Z-8633
B. Turcotte

TO:	CHAIR AND MEMBERS PLANNING & ENVIRONMENT COMMITTEE
FROM:	JOHN M. FLEMING MANAGING DIRECTOR, PLANNING AND CITY PLANNER
SUBJECT:	APPLICATION BY: 2403290 ONTARIO LIMITED 545 FANSHAWE PARK ROAD WEST PUBLIC PARTICIPATION MEETING ON NOVEMBER 28, 2016

Figure 2a)

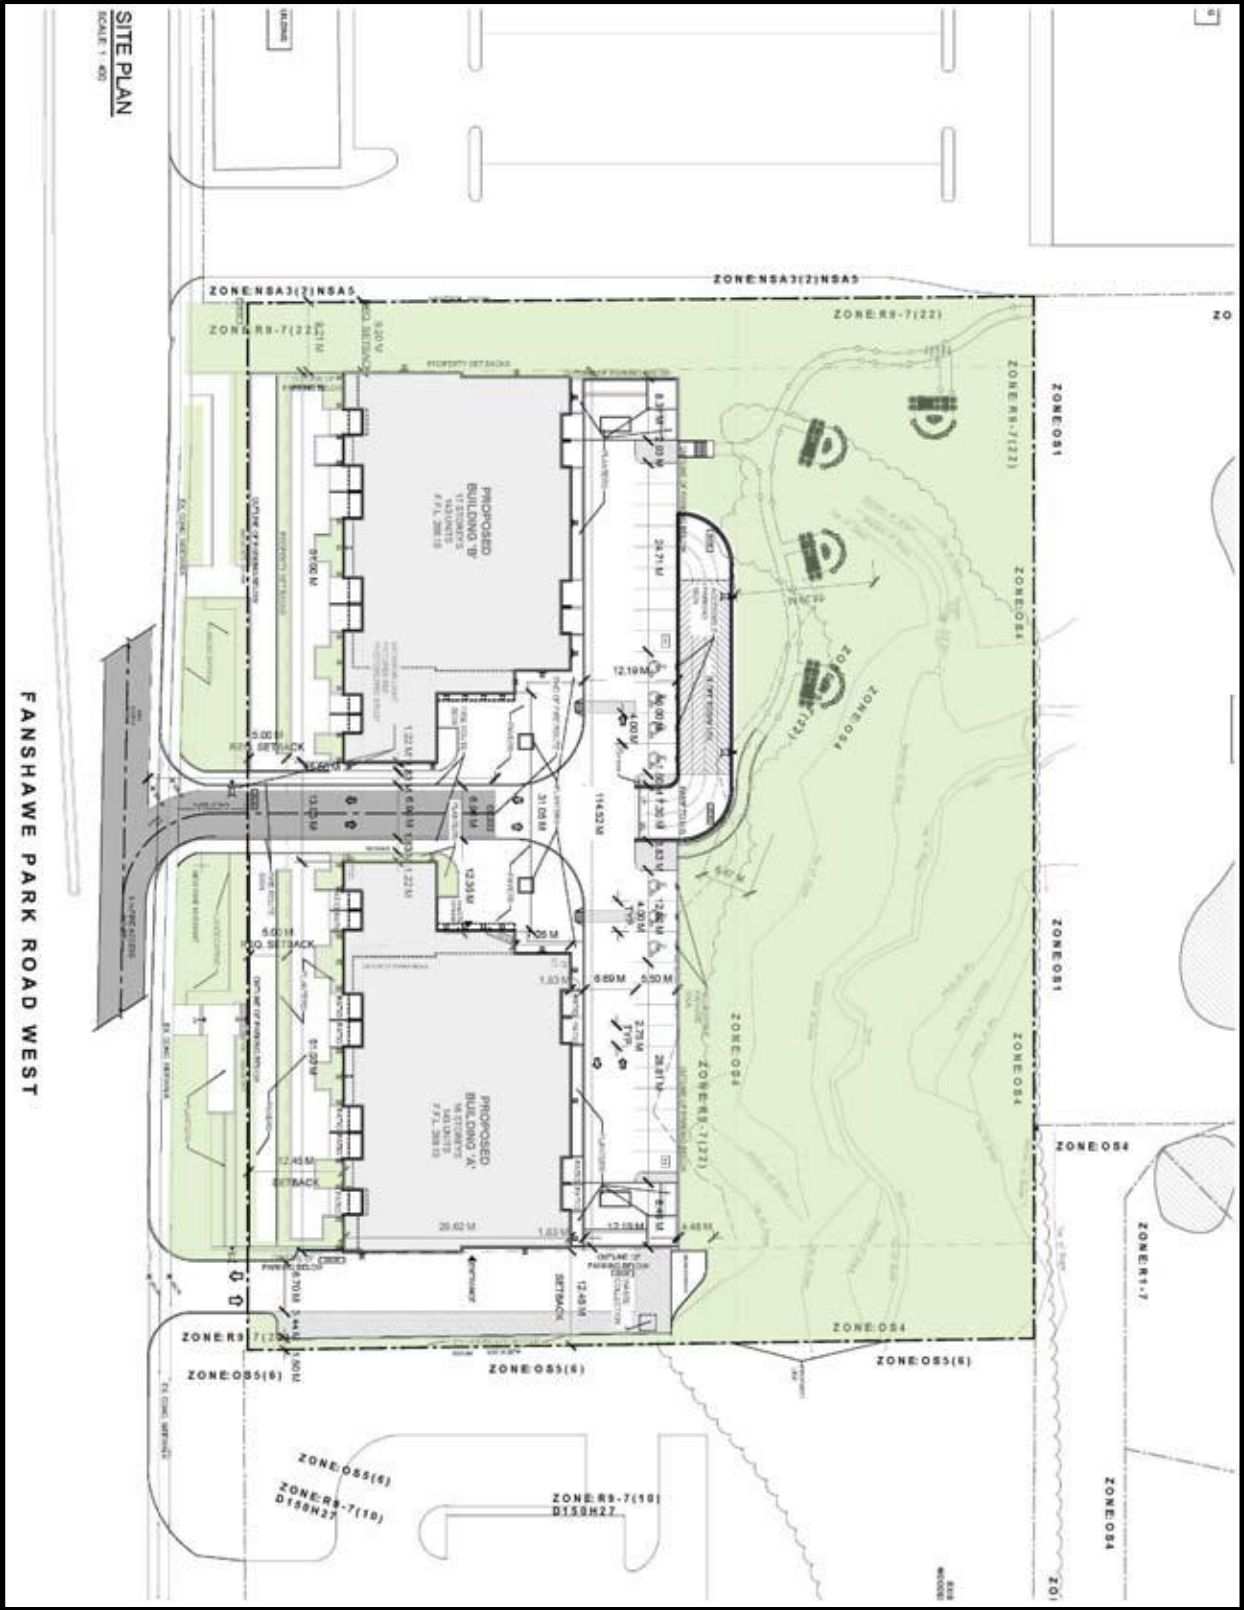
- *"Remove all steps, terraced walls, raised planters, and covered parking landscape buffers from the road allowance of Fanshawe Park Road West;*
- *Waste collection areas should not be designed to require three point turns or hammerhead;*

- *Provide a landscape buffer along the east side of the covered parking area near Fanshawe Park Road West to screen the exposed wall;*
- *Provide walkways along the north building facade to provide access to the amenity areas abutting the surface parking and ensure all parking areas and parking aisles are a minimum 3 from the building. Provide a minimum 3 m separation between parking areas and common amenity areas. Consider amalgamating the two small amenity spaces into one large amenity space;*

- *Expand the north western patio area to include access to the proposed stairway to the amenity areas near the OS4 boundaries;*
- *Provide details of all external lighting fixtures on the site plan as well as a photometric plan demonstrating no impact on abutting lands. Remove the proposed light standards from Fanshawe Park Road West along the central driveway;*

Figure 3b) - The Revised Development Proposal noting C of L Transportation Comments

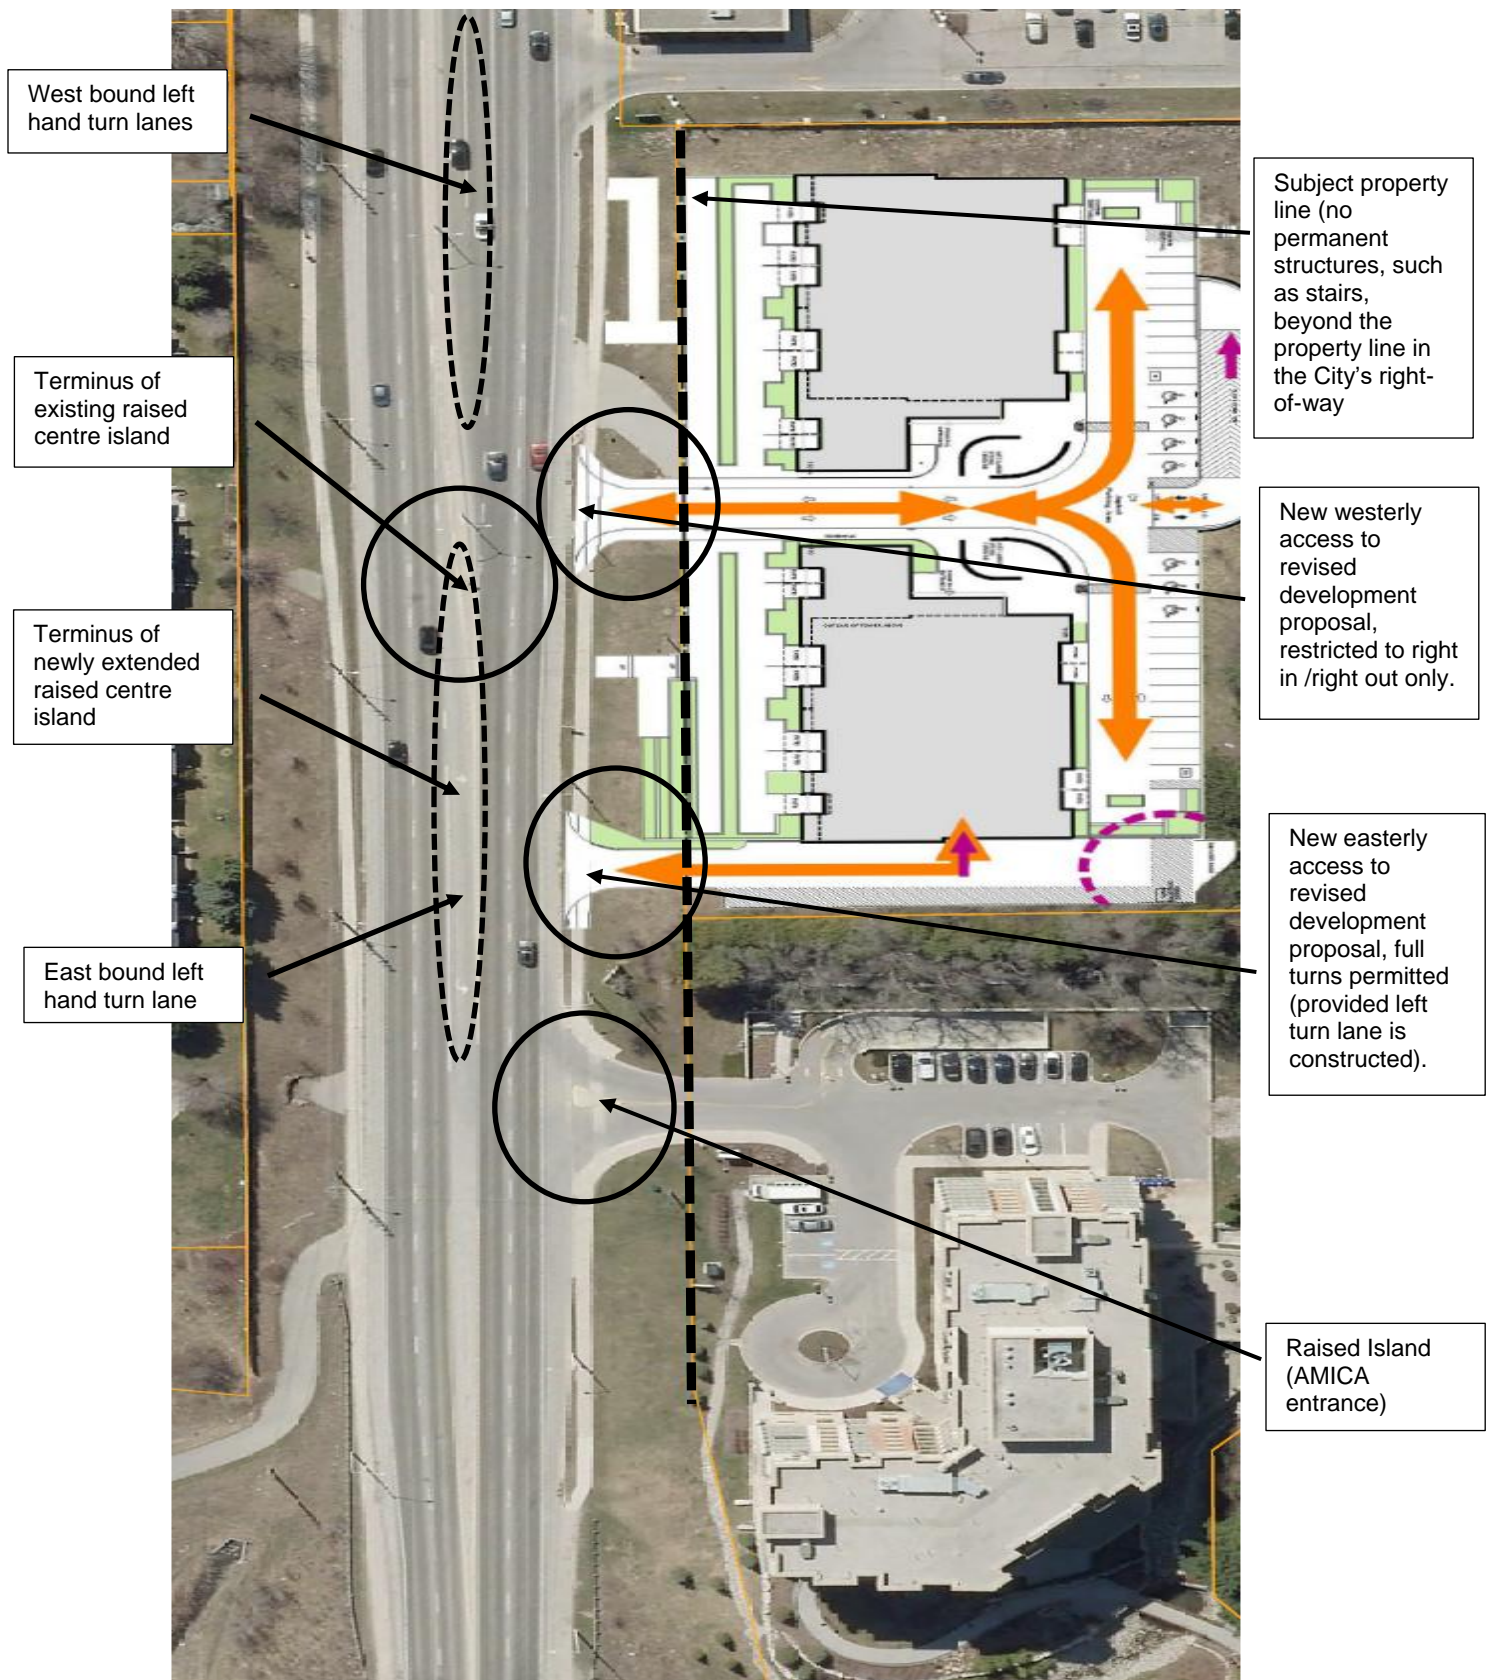
City of London Transportation staff have also reviewed the conclusions of the updated Transportation Impact Study and are in agreement with its conclusions. The recommended improvements to provide for the revised development proposal are illustrated on Figure 3b) to this report.

Figure 3b) also shows that a portion of the proposed landscaped terracing on the revised development proposal fall within the ultimate City road allowance. City of London Transportation staff have noted that no permanent structures within the City’s right-of-way are to be allowed. It is important to note that the landscape elements shown within the City’s right-of-way are not permanent but temporary structures that can be easily removed should it ever be required. It should also be noted that the developer will be required to enter into a Development Agreement and an Encroachment Agreement regarding the use and maintenance of lands within the City’s right-of-way for temporary design elements
